UNITED STATES PATENT AND TRADEMARK OFFICE

10/596,982

Office Action Summary	Application No. 10/596,982	Applicant(s) MUELLER ET AL.	
	Examiner Richard R. Green	Art Unit 3644

DETAILED ACTION

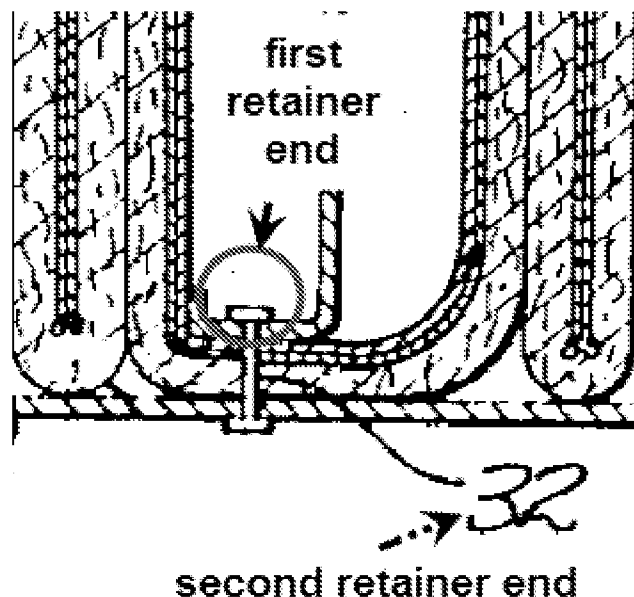
a fuselage with stringers stiffening panels of an outer skin of the fuselage (figs. 1 and 2, stringers at 22 stiffen panels 23) and ribs arranged perpendicular to the longitudinal axis of the aircraft (figs. 1 and 2, ribs at 20), where the ribs are attached to the stringers at one end (figs. 1 and 2, as where left numeral 20 points in fig. 1) and unattached at another end, culminating in an integrated rib carrier (fig. 2: rib 20 ends in a 90 degree bend, which is a rib carrier), and the ribs further having a rib attachment region located between the attached end and the rib carrier and further having a hole through the rib attachment region (fig. 1, element 32 is received through a hole in the topmost portion of rib 20, which is located between the lip shown to the left of element 32 and the attached end shown touching the stringer 22); and

a pair of fuselage insulation packages having an elongated package shape and being arranged longitudinally with respect to the fuselage and resting against a support surface of the stringers (fig. 1, at 17; another is shown to either side, both are elongate in shape – see particularly fig. 3 – and arranged longitudinally while resting against a surface of the stringers 22 as in fig. 1) and are attached to the fuselage (fig. 1, packages 17 are attached to the rib 20 through element 32, which rib being part of the fuselage), each comprising:

first and second flat end sections on opposing sides of the package, the second end shorter than the first (fig. 1: first end on left, second end on right; in light of col. 4, lines 4-7 where the packages overlap in the region of the attachment element 32, the packages are considered to terminate near the attachment element 32, and as such in fig. 1, the left end of insulation package 17 is shown to be longer than the right end),

arranged to overlap in a region of attachment such that an attachment element passes through the hole in the rib attachment region and both the first end of one of a pair of packages and the second end of the other of a pair of packages, both packages having holes formed in both ends where the attachment element passes through (fig. 1, at and around element 32 and in light of col. 4, lines 4-7); and

a foil completely enclosing a fire-stop insulation or barrier layer (fig. 1, foil at 16, flame resistant insulation at 10; col. 3, lines 54-60 teaches that the insulation 10 is fire-stop, which is considered to comprise "burn-through-proof"); and

a "burn-through-proof" attachment element having first and second retainer ends at opposing ends (fig. 1, particularly enlargement above: first retainer end is the fastener circled and labeled, second retainer end is the spacer 32 – the attachment element is the combination of the two pieces and is considered to be "burn-through-proof" in the same way that waterproof watches are only waterproof to a certain depth and fireproof materials are only fireproof to a certain temperature and duration of exposure to

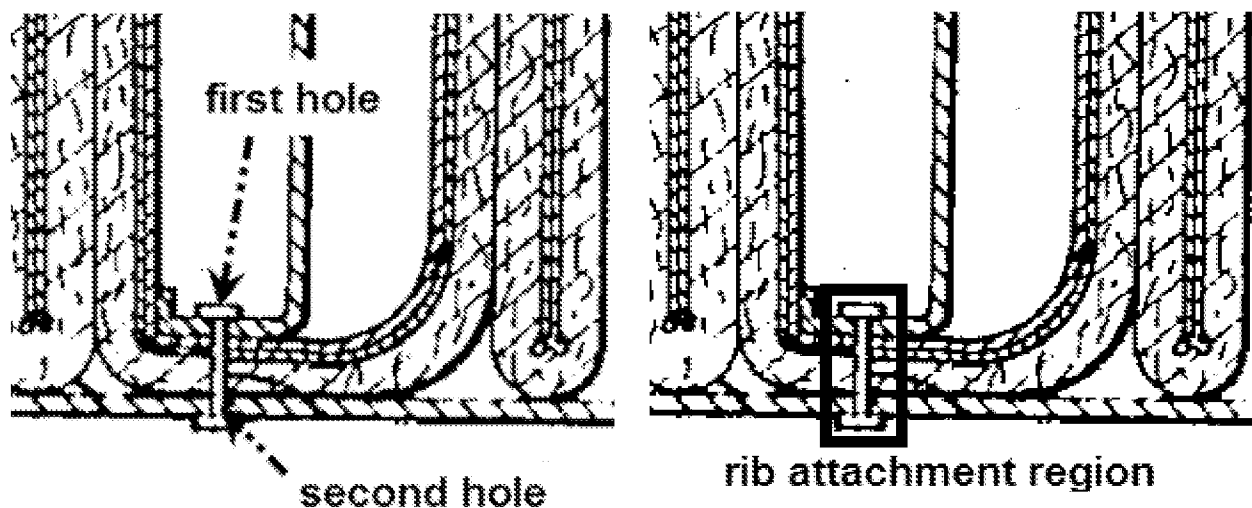
stringers for stiffening panels of an outer skin of the fuselage (figs. 1 and 2, stringers at 22 are capable of stiffening outer skin panels 23) and ribs arranged perpendicular to the longitudinal axis of the aircraft at a specified distance (figs. 1 and 2, ribs at 20 are a distance apart), where the ribs are attached to the stringers at one end (figs. 1 and 2, as where left numeral 20 points in fig. 1) and unattached at another end, culminating in an integrated rib carrier (fig. 2: rib 20 ends in a 90 degree bend, which is a rib carrier), and the ribs further having a rib attachment region located below a longitudinal side of each of the ribs adjacent the attachment region (fig. 2, the flat inside edge of the ribs 20 is an attachment region which at the top of the aircraft is below a longitudinal side of the ribs);

at least two fuselage insulation packages having an elongated package shape and being arranged longitudinally with respect to the fuselage and resting against a support surface of the stringers (fig. 1, at 17; another is shown to either side, both are elongate in shape – see particularly fig. 3 – and arranged longitudinally while resting against a surface of the stringers 22 as in fig. 1) and are attached to the fuselage (fig. 1, packages 17 are attached to the rib 20 through element 32, which rib being part of the fuselage), each comprising:

a foil completely enclosing a fire-stop insulation or barrier layer (fig. 1, foil at 16, flame resistant insulation at 10; col. 3, lines 54-60 teaches that the insulation 10 is fire-stop, which is considered to comprise "burn-through-proof") and wherein the packages

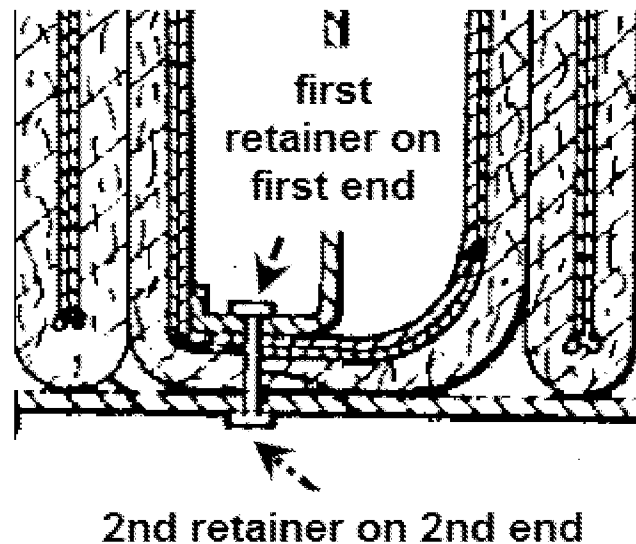
wherein a hole is drilled through the rib attachment region (fig. 1, element 32 is received through a hole drilled in the topmost portion of rib 20, which is located between the lip shown to the left of element 32 and the attached end shown touching the stringer

22), a first hole is formed in a package region of each of the two insulation packages and a second hole is formed in the flat end section of each of the two insulation packages, wherein the first and second holes are retained on opposite sides of the rib attachment region by the “burn-through-proof” attachment element (fig. 1, particularly above enlargement – in fig. 1 this arrangement occurs twice and so a similar arrangement as follows is considered for the other side of the middle insulation package 17 – the first hole is formed in the insulation package through layer 16 on the side of the package closest the skin of the airplane and the second hole is formed in the insulation package through layer 10 on the side of the package closest the interior of the fuselage; the rib attachment region being considered the three dimensional region where the package is attached to the rib – as in the enlargement of fig. 1 above – whereby the first hole and the second hole are retained on opposite sides of the rib attachment region by the attachment element).

Regarding claim 3, Lea teaches the insulation package arrangement of claim 2, wherein the attachment element comprises a “burn-through-proof” insulation pin (fig. 1, spacer 32 is an insulation pin, which is burn-through-proof for the same reasons the attachment element is), and the attachment element is fed through the first hole, the through hole of a respective rib, and the second hole, when these elements are arranged so as to be substantially congruently aligned (fig. 1, particularly above enlargement regarding claim 2: the attachment element is fed through the first hole, the second hole, and the hole in the respective rib, when these holes are lined up).
